Meadowbank Dike Review Board Reports

Report No 19
Meadowbank Mine Dike Review Board
Meeting September 19-22, 2016

SUBJECT: RESPONSE TO REPORT No.19, MEADOWBANK DIKE REVIEW BOARD

Photo no. 5 Pond at Toe of Central Dike

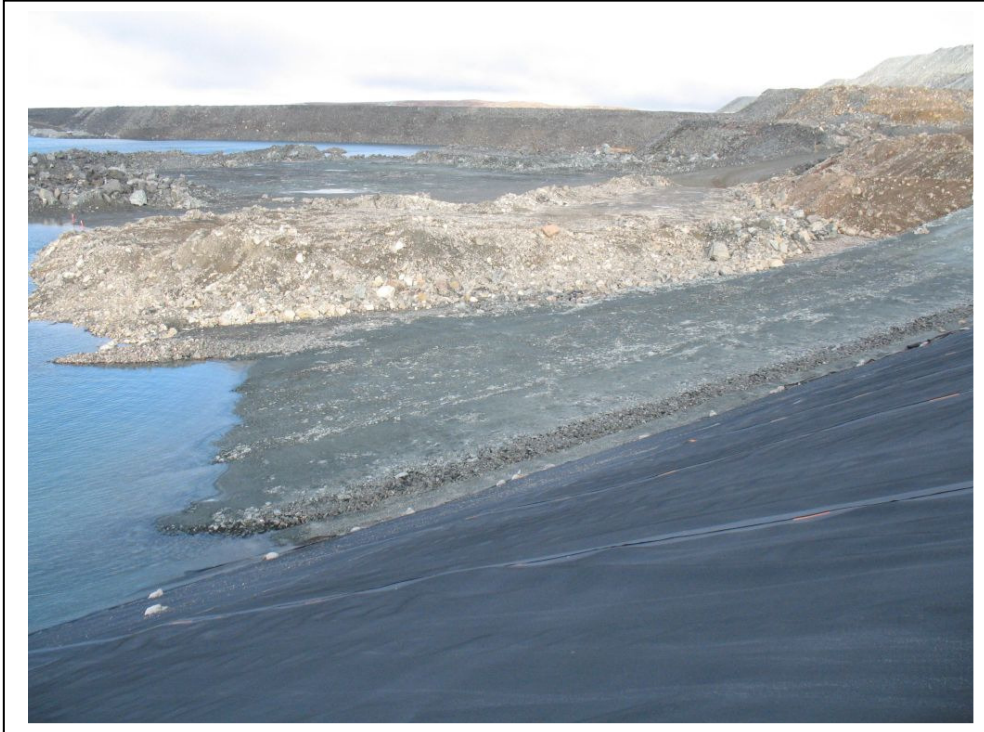
A site visit permitted the Board to appreciate the pumping installations that have been operated of late (photo no. 4) and to learn of plans to install electrically powered pumps to facilitate the control of flow rates and thus the pool elevation. The pool depth is sufficient to submerge the points of inflow. No concentration of suspended sediments was in evidence at the time of the visit nor has any been noticed by the site team outside of freshet run-off period. However, the pond water is not completely clear as can be noted from photo no. 5. The leakage appears to be managed effectively at present.
